Re: Catawba Nuclear Station
Docket Nos. 50-413 and 50-414

Request for Additional Information

Impact of Elimination of Postulated
Circumferential and Longitudinal Pipe Breaks
in the Pressurizer Surge Lines

CATAWBA SURGE LINE

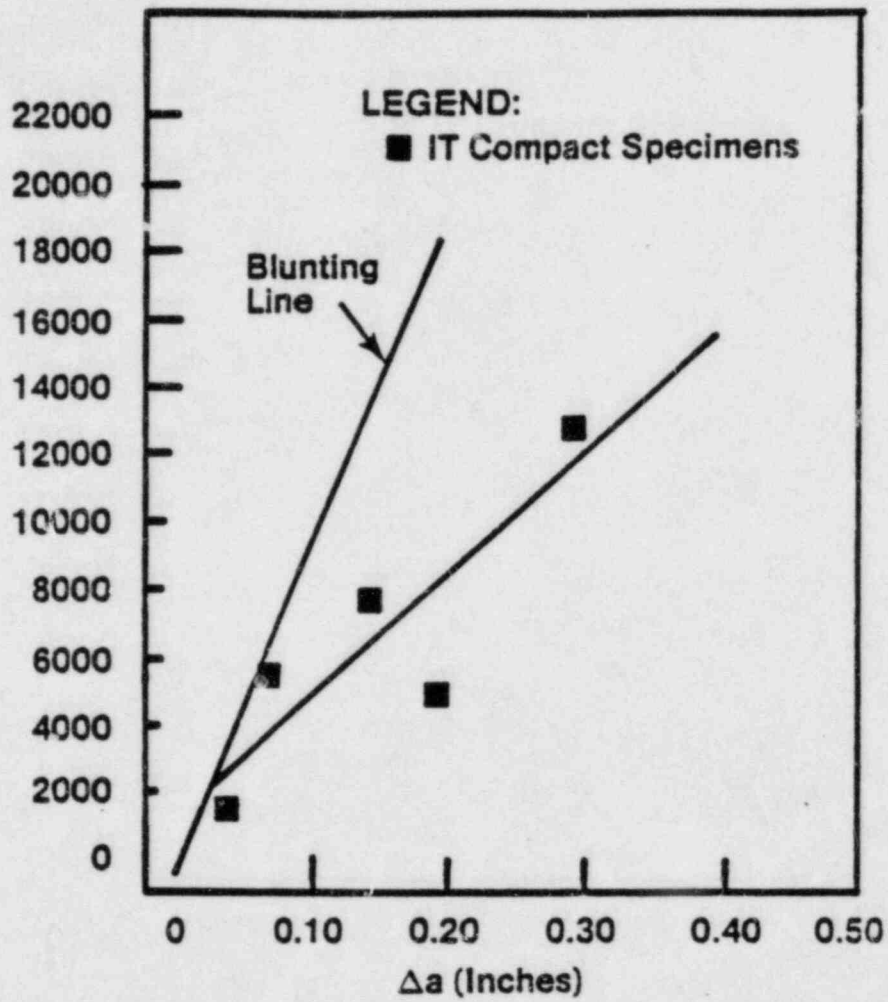
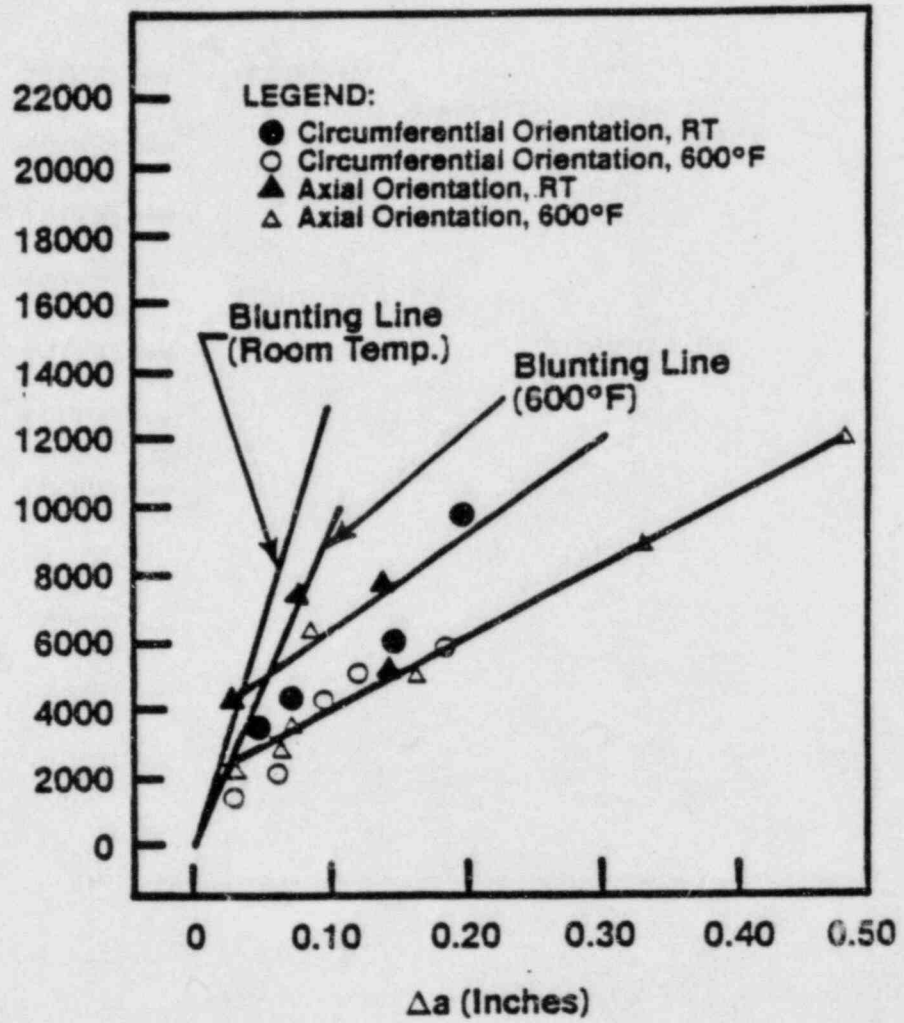
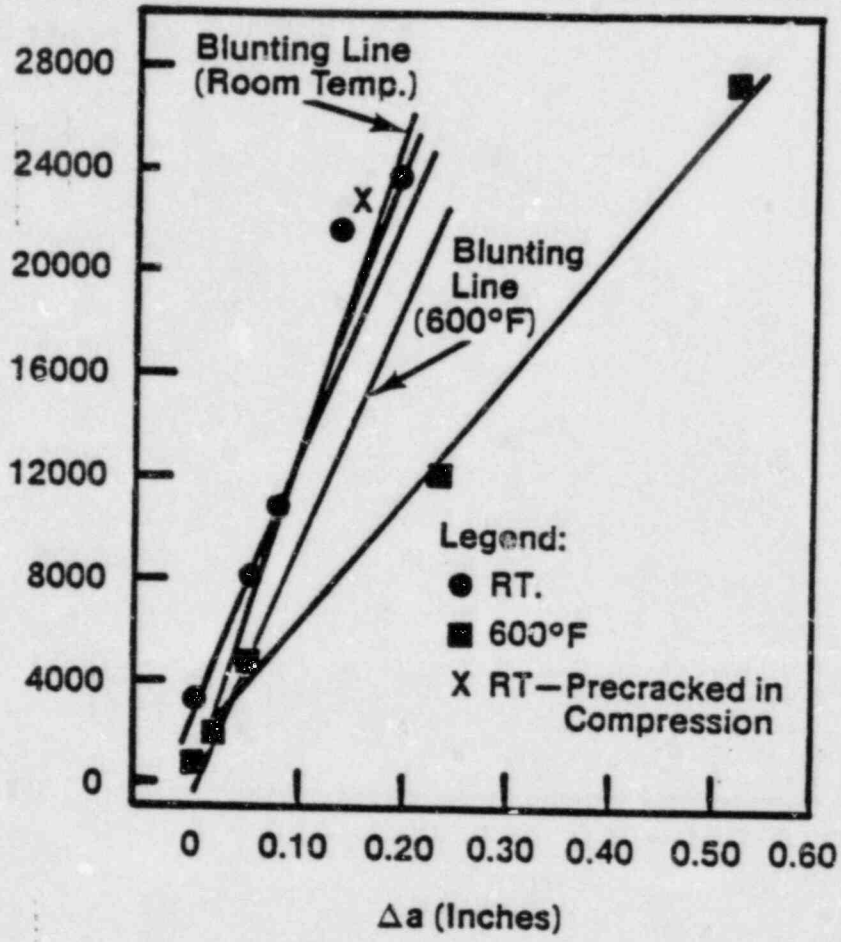
The Paragraph at the top of page 3-2 of Reference (a)* below identifies the weld connection between the [] as being a,c,e
the limiting location to be analyzed. Figure 7-2, page 7-12, is a schematic drawing of this location. Provide the materials properties for the weldment as well as for the base metal, preferably in the form of a J-resistance plot. State the maximum value of J-material to be considered in your analyses and your basis for it.

The fracture toughness J_{IC} used for the 304 forged pipe was obtained from the compilation of test results for this material reported in Reference 1. The table of toughness results presented in this reference is reproduced in the attachment. It is easily seen that the value of [] used in a,c,e
the report is the minimum of the three sets of test results reported. The J integral R curves for each of the three sets of tests at 600F are also provided in the attachment, and are the original figures from Reference 1.

The maximum value of J obtained in the fracture tests is in excess of 25000 as may be seen from examining the plots attached for base metal tests. The maximum value of J obtained in the weld metal tests was in excess of [] in-lb/in². a,c,e
